**Re: Trapper Mining Inc., Permit No. C-1981-010
Phase I Bond Release Application SL-25
Adequacy Comments**

The below adequacy, comments were received from the Division on January 10, 2024. Trapper Mine responses follow each adequacy comment. Revised copies of Map 1, Sheets 1 and 2 are attached.

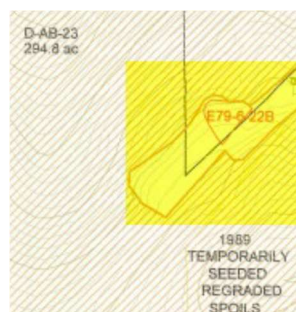
3. The following illustration highlights a parcel that is unidentifiable to DRMS as it lands on the seam between the two map sheets. Please clarify the parcel nomenclature on Map sheet 1 and associated acres with a revised map, possibly utilizing a call out block for visibility.

Trapper Response: This parcel labeled a remnant parcel of Phase III release to the east of this label on Sheet 2 of the Map 1. The map has been revised with better label placement.
